Appendix A Revised plant layout and elevation plans

**Rosehill Recycled Water Scheme
Revised pipeline alignment, North St
Doc No: PORRW-PL-A-0029 Rev: 1
Date: 16/03/09
Size: A4**

Rosehill Recycled Water Scheme – revised Noise and Vibration Impact Assessment

Appendix D Detailed response - Fairfield City Council

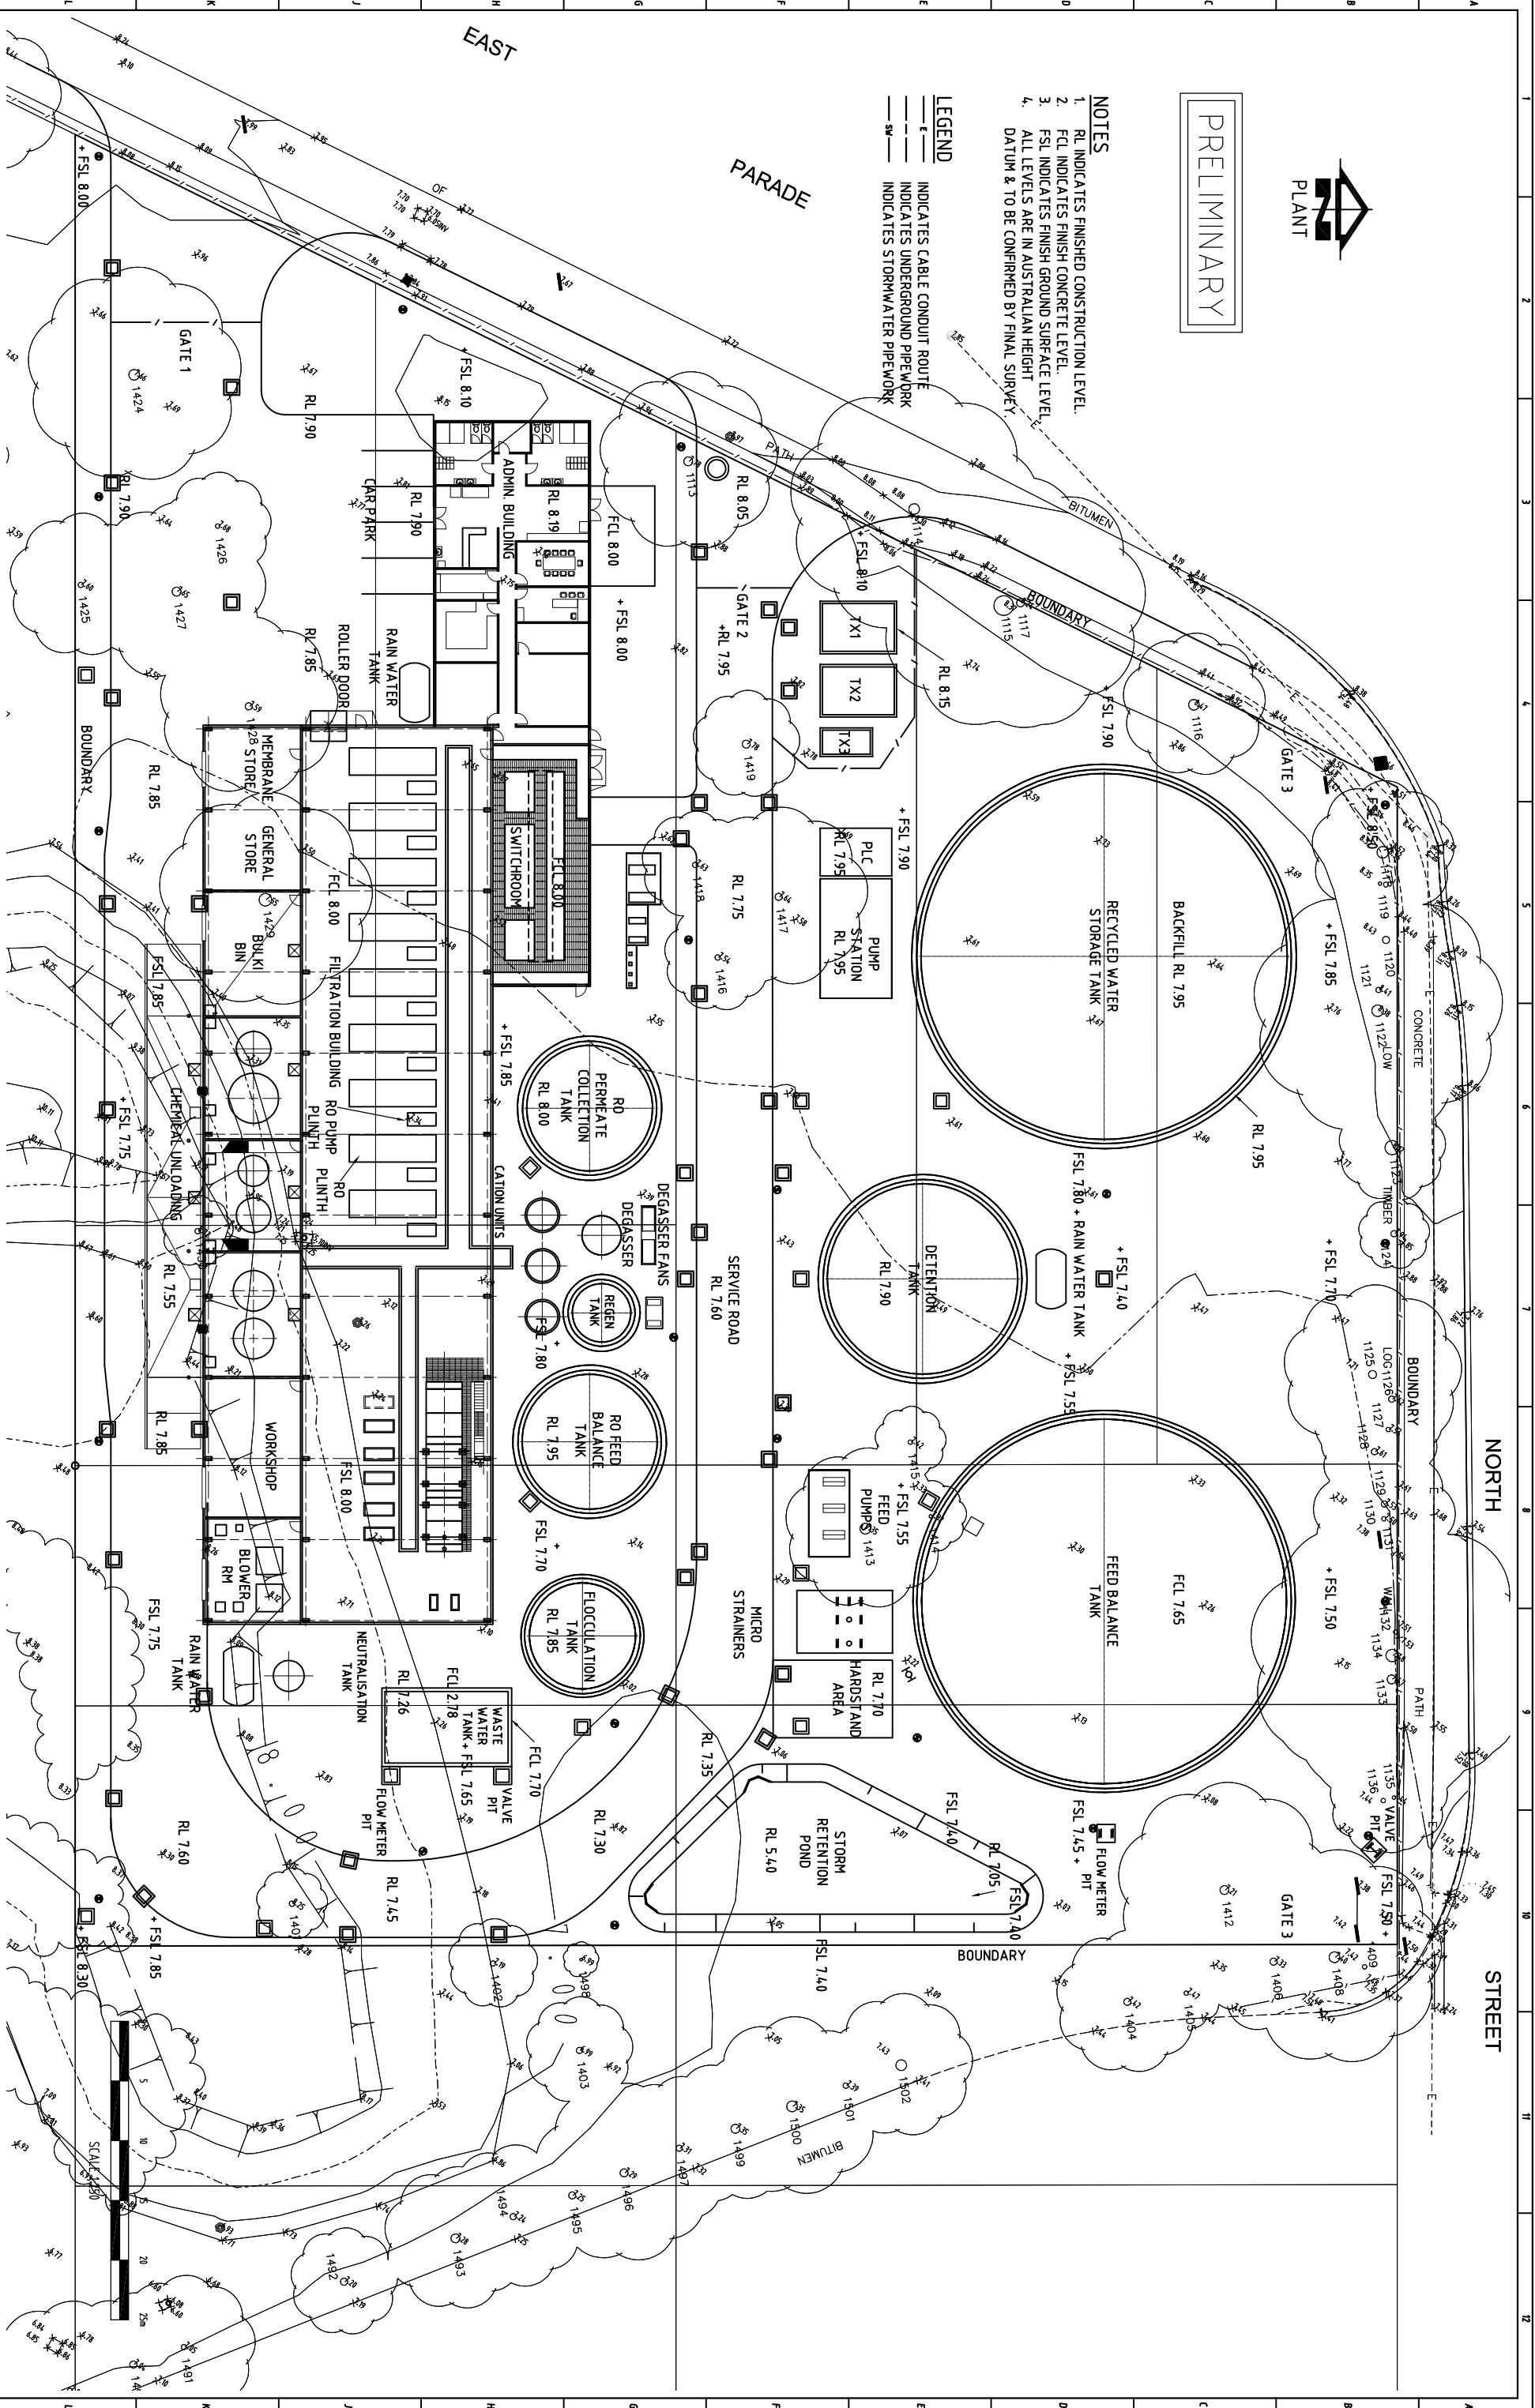
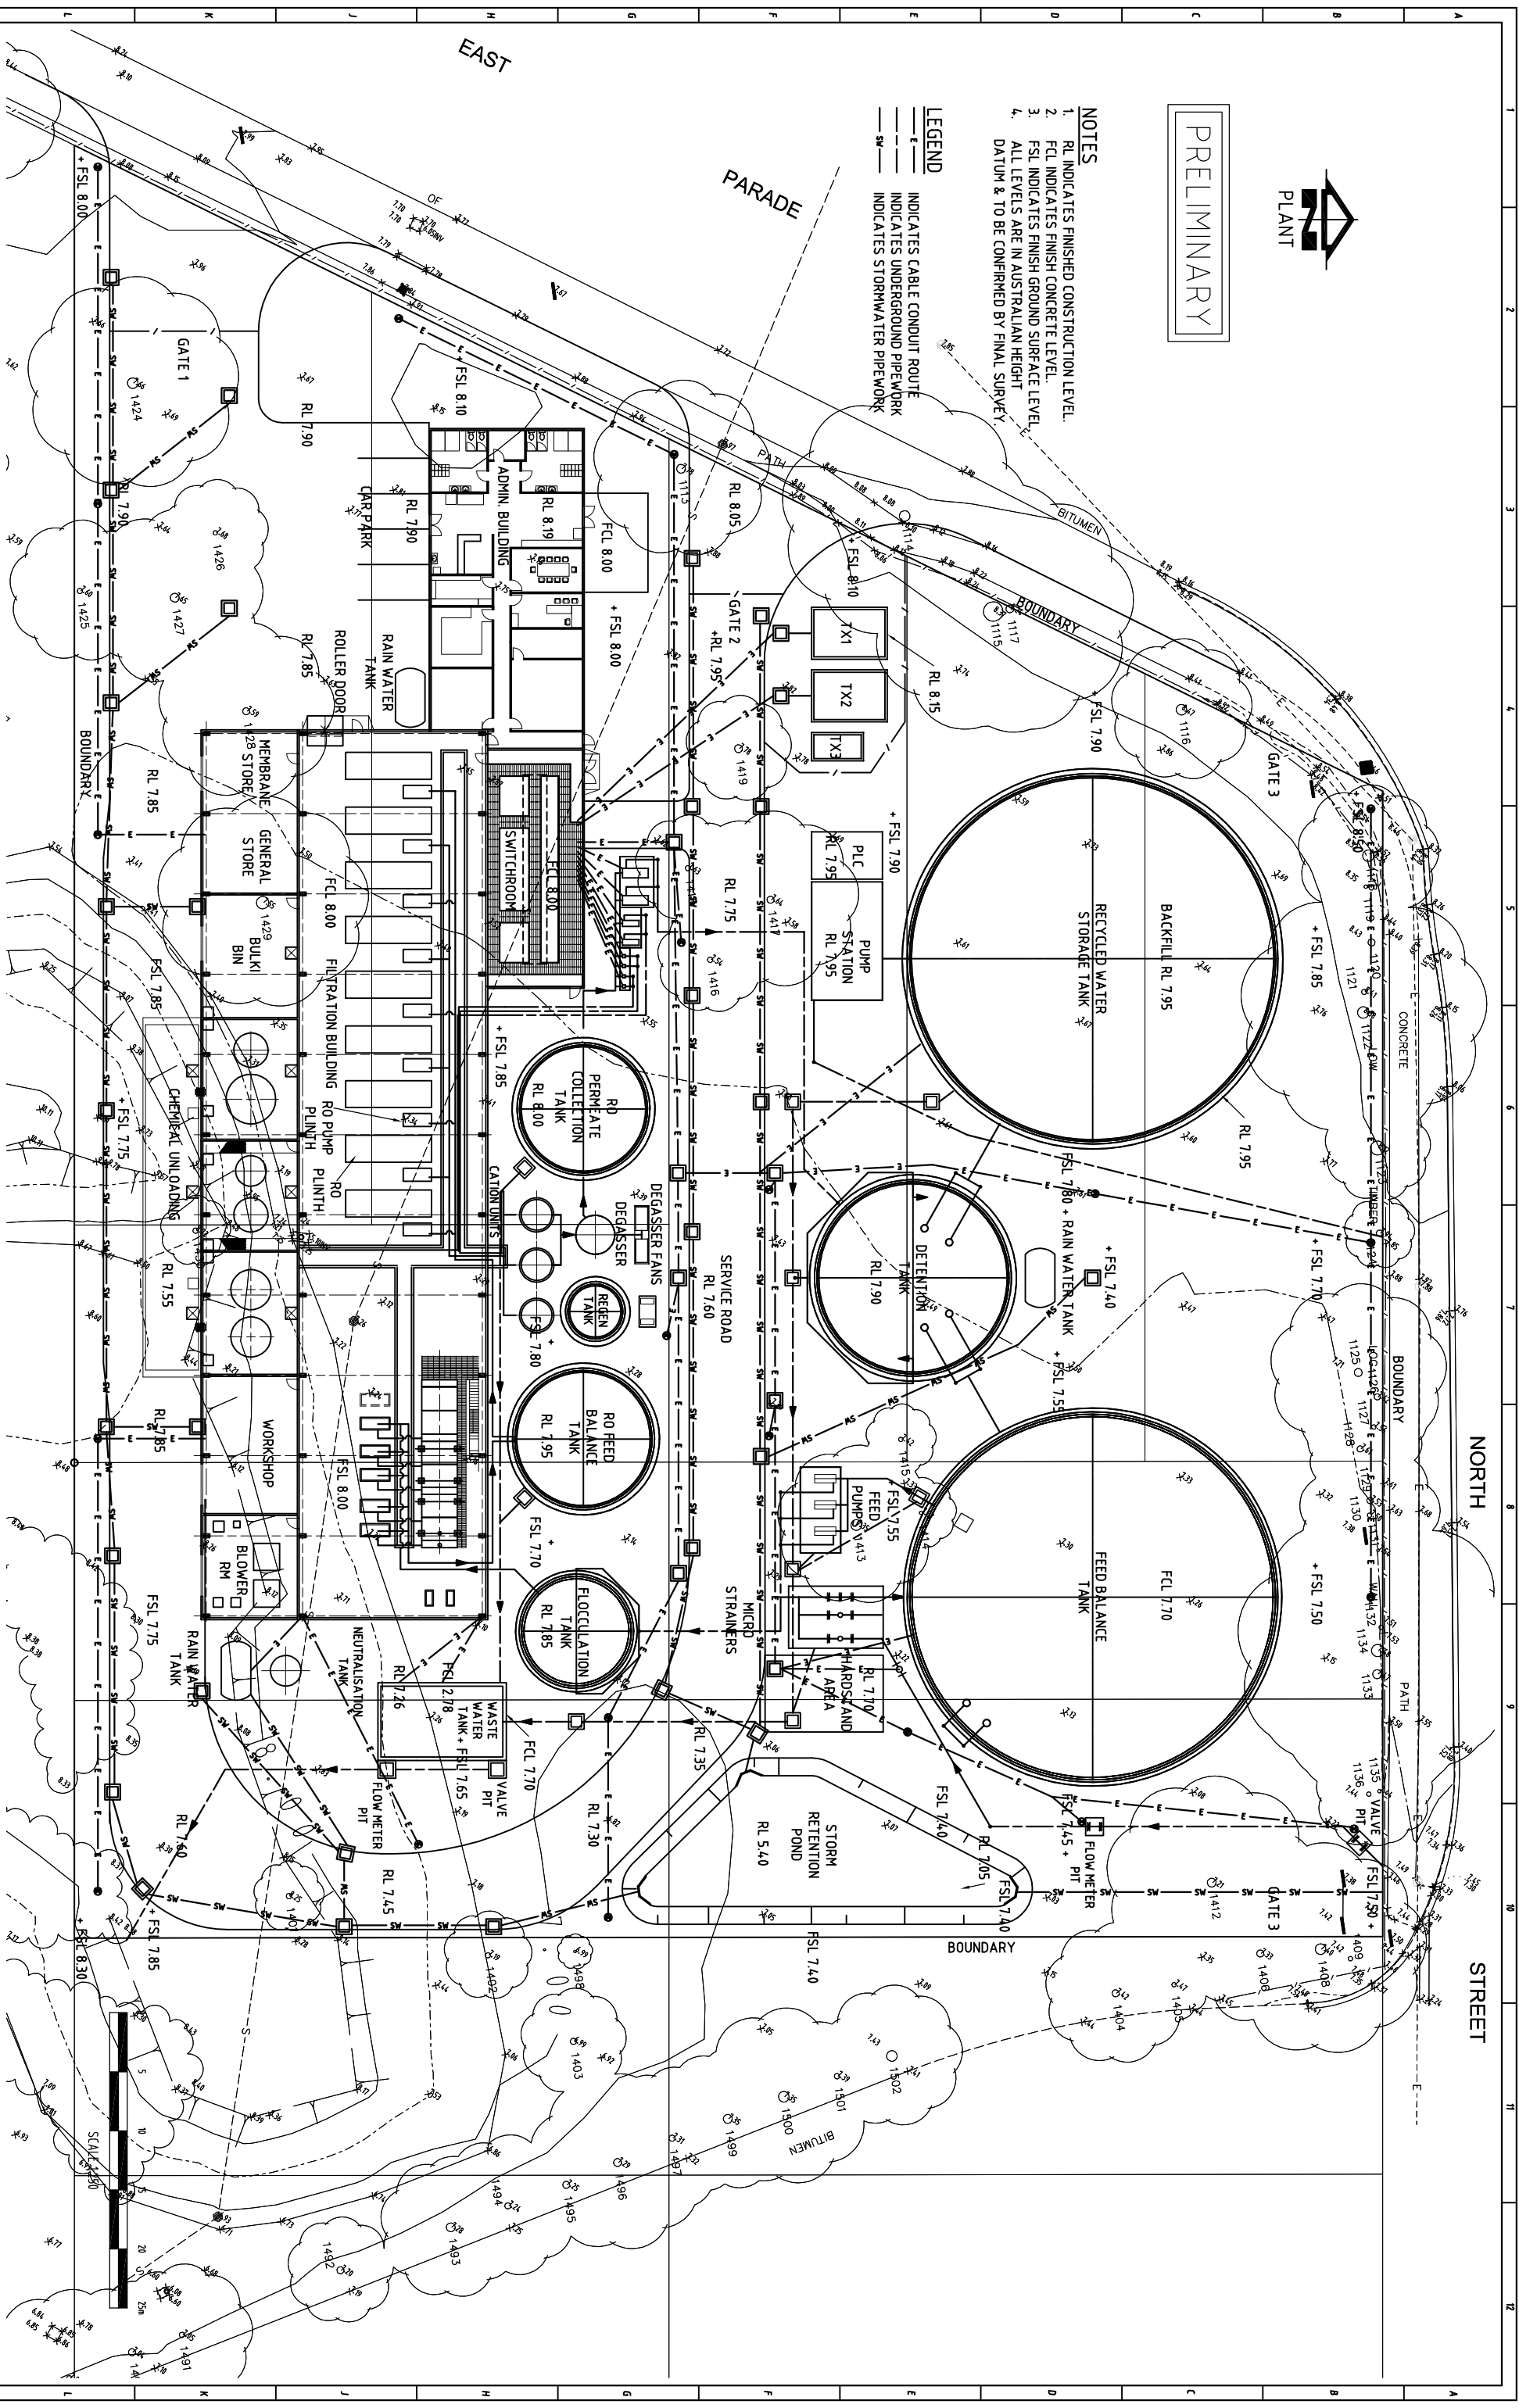
REV	NO	DESCRIPTION	DATE	BY	CHECKED	APPROVED
1	1	ROAD MOVED	29/01/09	JEM	SS	CD
2	2	BUILDING UPDATED	23/12/08	JEM	SS	CD
3	3	TRANSFORMERS RELOCATED	12/12/08	JEM	SS	CD
4	4	SW & ELEC ROUTE ADDED	03/12/08	JEM	SS	CD
5	5	PUMP STATION RELOCATED	06/11/08	JEM	SS	CD

Figure 1 Proposed revised Fairfield Recycled Water Treatment Plant

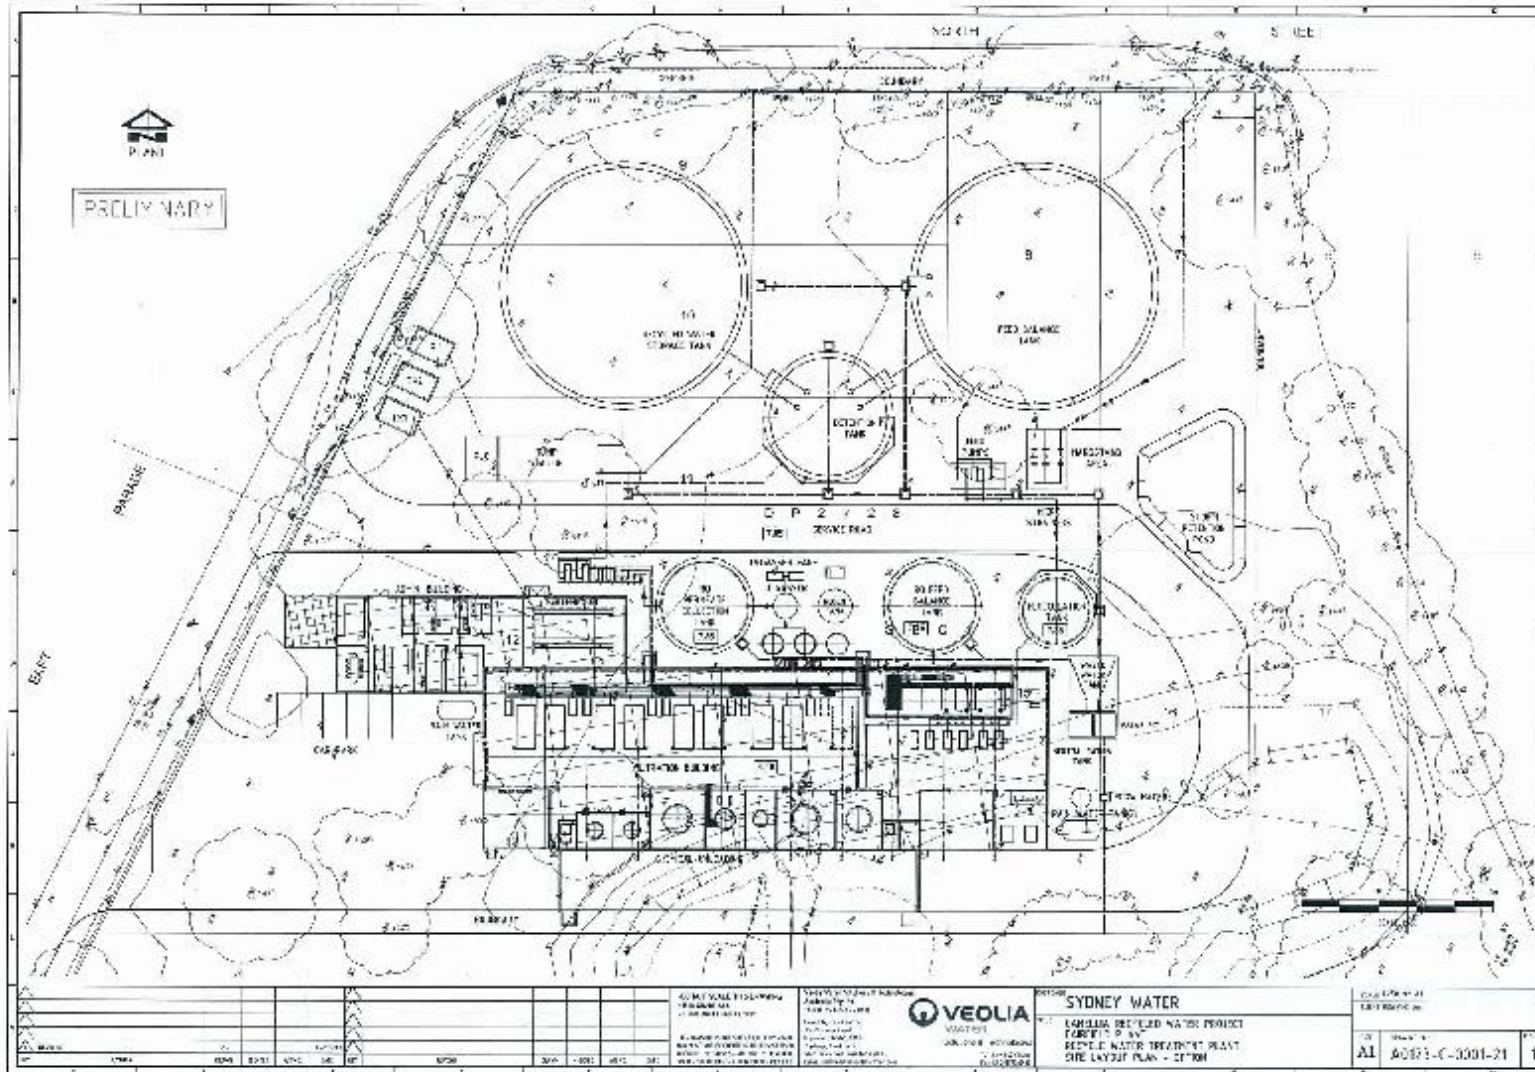
The RWTP site has been redesigned as per drawing *A0123 – C 0001 – 21 Issue 1*, detailed in enclosed Figure 1. The water pumps, housed in the water pump station, have been relocated from the eastern site boundary to south of the Recycled Water Storage Tank at the western site boundary.

- Revised pump station location as per enclosed Figure 1.
- Two pumps of SWL 88 dB(A) in cumulative operation, cumulative total SWL 91 dB(A).
- Adopting INP guidance, no modifying correctional factors for tonal or low frequency potential disturbing source noise characteristics have been applied.
- Pumps to operate on an as required basis during 24 hour periods.
- Nearest receivers located at 70 - 150 meters from the pump station.
- Potential attenuation to received noise levels of 10 dB(A) from the intervening 4.8 ML Recycled Water Storage Tank (6 meter height) at all receivers except Railway Parade
- Neutral metrological conditions

A design option to house the water pumps in a sheet steel structure comprising of continuous solid walls facades and a roof structure has been considered as a potential feasible noise control measure. The pump station housing would be expected to require ventilation openings and access doors on the side facades.

The location of required ventilation openings and access doors to the south façade of the pump station or the application of acoustic pressure relief louvers and solid doors with doors seals would be expected to provide required reductions to internal noise breakout to meet the design objective of 85 dB(A) $L_{Aeq, 15min}$.
